March 17, 2016

Florida Power & Light Company (FPL) appreciates the effort extended by Miami-Dade County Department of Environmental Resource Management, the Miami-Dade Board of County Commissioners, and the University of Miami in collaborating on a review of the Turkey Point Cooling Canal System (CCS). As a technical organization, we are committed to the pursuit and application of thorough scientific analysis and welcome the observations of other like-minded individuals and organizations. As can be noted by a review of Dr. Chin's report, the CCS is a complex system whose comprehensive analysis involves a wide range of disciplines and is subject to many influencing factors. We note that Dr. Chin's review was limited by the lack of any direct interaction with FPL engineers and scientists, or the body of data that has been developed to characterize and understand the various forces in action within the system. Not unexpectedly some of the assumptions employed by Dr. Chin are not consistent with our observations or practical limitations. Moreover, we regret that Dr. Chin's work does not reflect the significant results of FPL's concerted efforts undertaken in 2014 and 2015 to address d

Figure 1. CCS Water balance deficit (Evaporation – Rainfall)

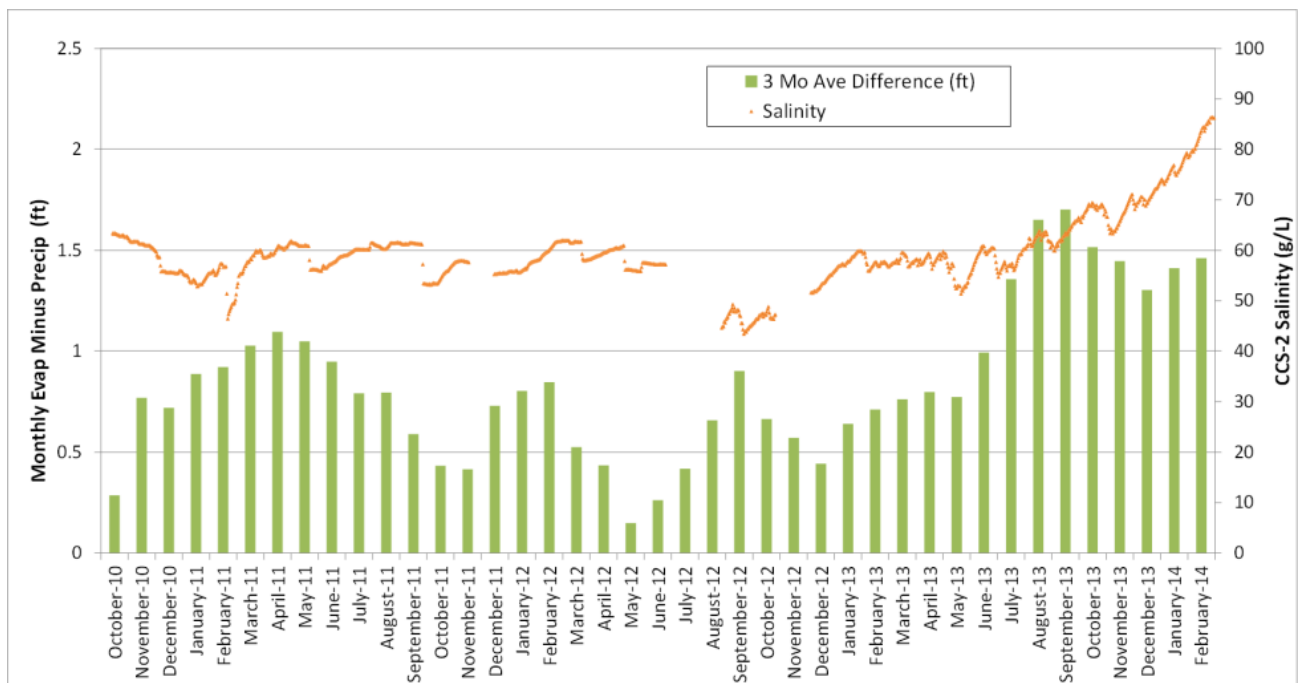
- Lower than average precipitation into the CCS during 2011 through early 2014 established a deficit of rainfall and reduced stage levels in the system. See Figure 1.

Figure 2. CCS Water quality observations

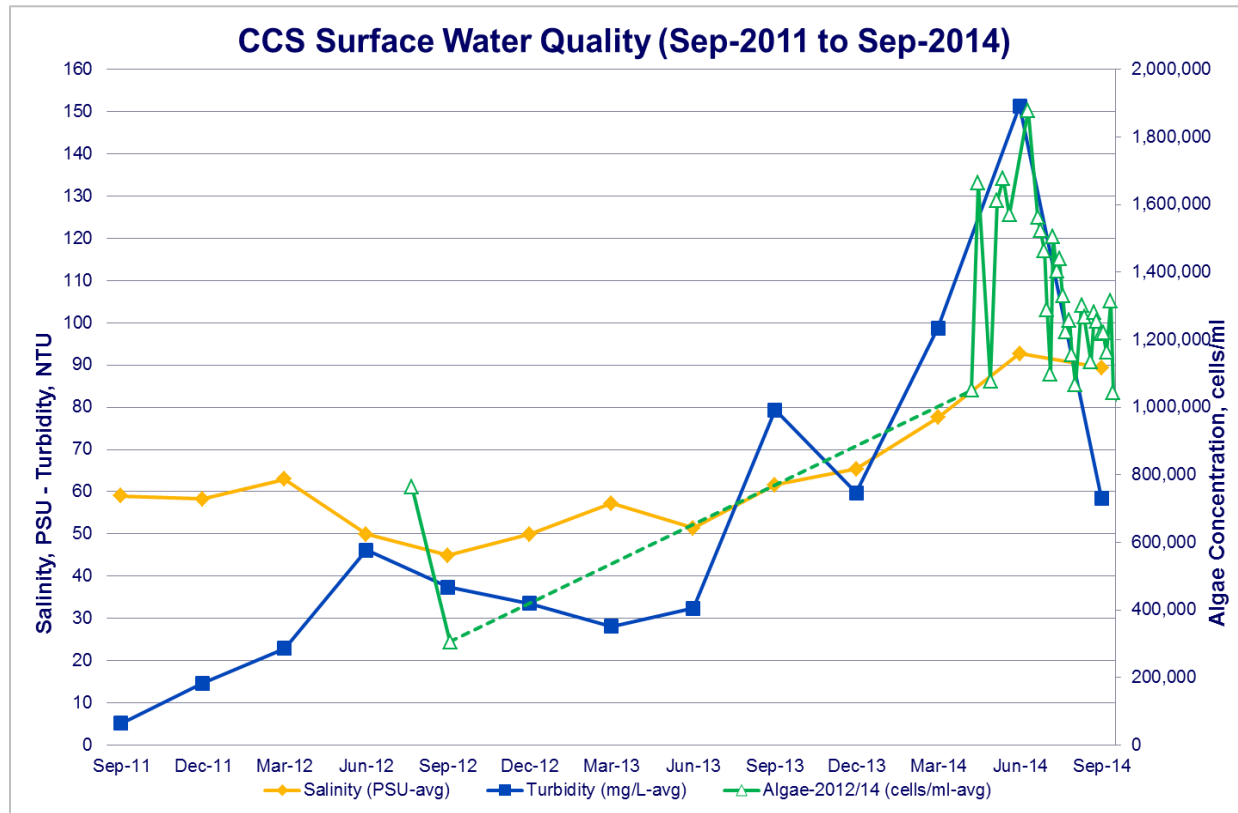
- In late 2013 and early 2014, salinity increased above historically observed peak levels. High turbidity and algae concentrations were observed out of the normal seasonal occurrences. Significant rainfall did not begin until mid-July 2014. Significant canal blockages in the upper segments of the CCS were observed, particularly during periods of low stage levels prior to rainfall. See Figure 2.

Figure 3. CCS Heat Exchange Efficiency history

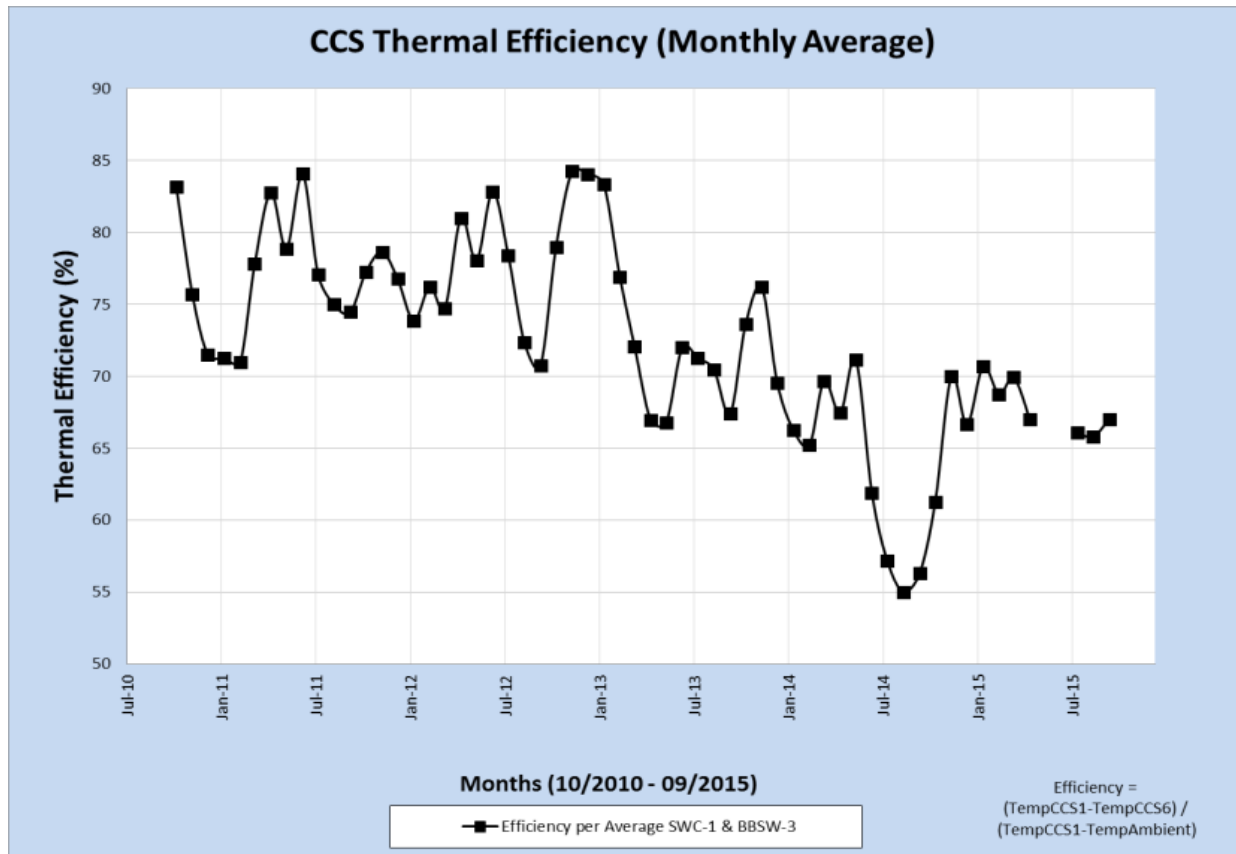
- A review of CCS heat exchange efficiency shows a decrease from a historic level of 75% efficiency to 65% in early 2013 followed by a decrease to 55% in early 2014. Significant blockages and sediment levels were noted, principally in the northern segments of the CCS. See Figure 3.

Figure 4. Aerial Thermography showing improved CCS heat rejection in 2015

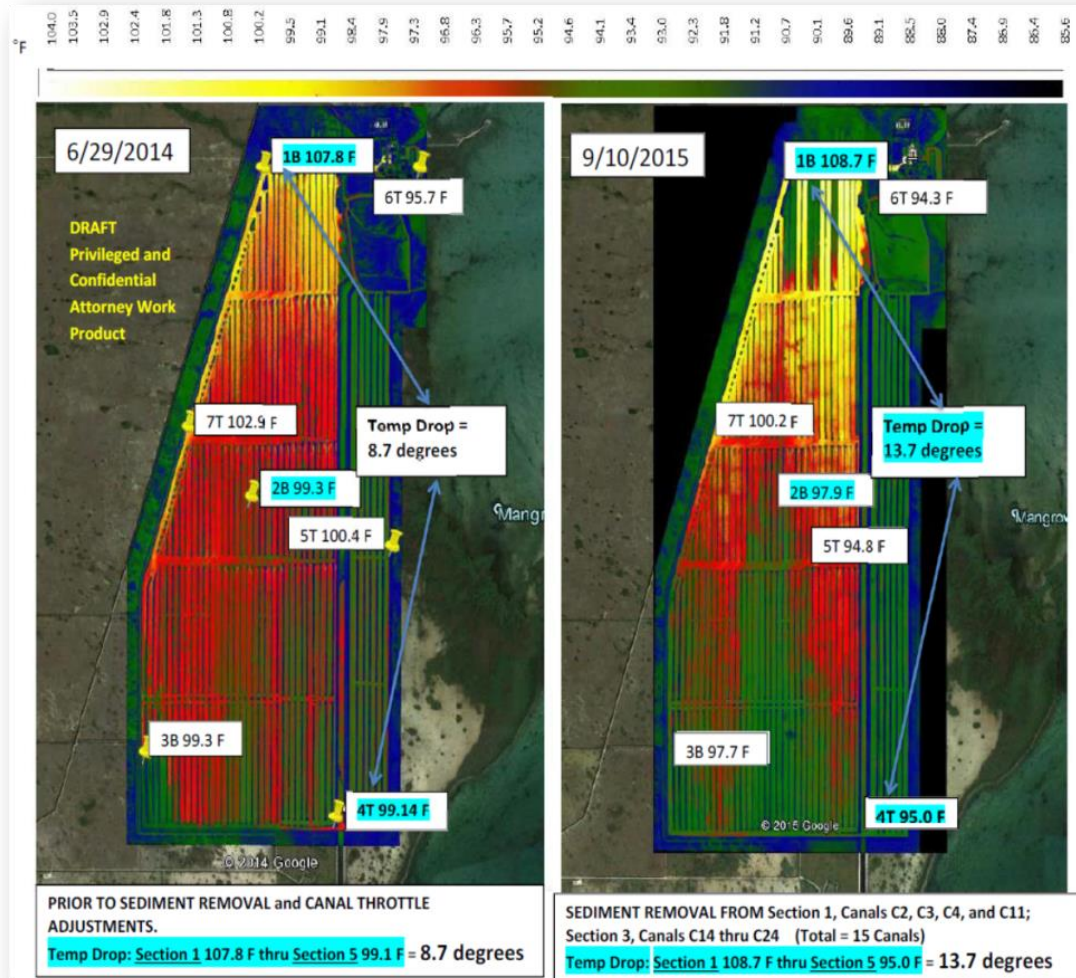
- Elevated temperatures in the CCS approached the Ultimate Heat Sink (UHS) Technical Specification limit of 100°F, requiring multiple power reductions to maintain compliance in the summer of 2014. The UHS Technical Specification limit was subsequently amended to 104°F.
- Sediment removal was conducted March through October 2015 to redistribute flow and recover design depths in portions of Section 3 and Section 1. Aerial thermography comparing August 2014 vs August 2015 conditions confirm improved cooling and flow distribution in the system. CCS heat exchange efficiency improved to approximately 65% in August 2015. This is in spite of the fact that five of the canal segments were blocked for sediment maintenance activities during this period. See Figure 4.

Figure 5. Daily average salinity in lower portion of L-31E (TPSWC-1 and TPSWC-2)

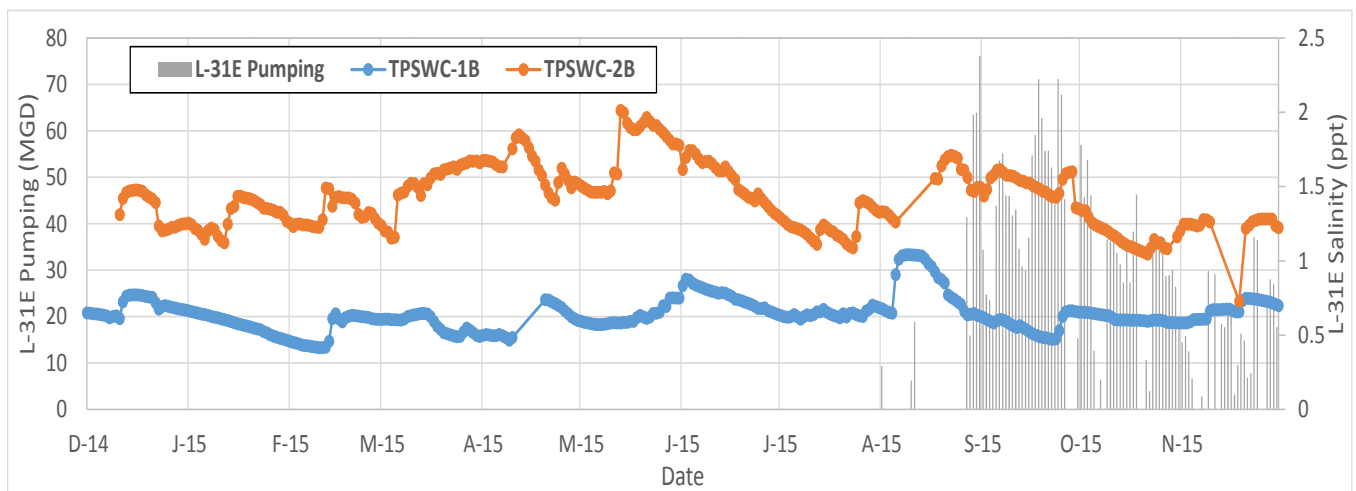
- Between August 27 and November 30, 2015, FPL conducted near-sustained pumping from L-31E into the CCS (approximately 30 MGD). During this time, there was no evidence of increasing salinity within even the deepest portions of L-31E adjacent to the CCS. The figure below illustrates the daily averaged salinities in L-31E in the bottom sensors at stations TPSWC-1 and TPSWC-2. Inspection of this figure reveals that there is no notable increase in L-31E salinity (orange and blue lines) beyond the natural fluctuations over the prior year, between late-August and the end of November. See Figure 5.
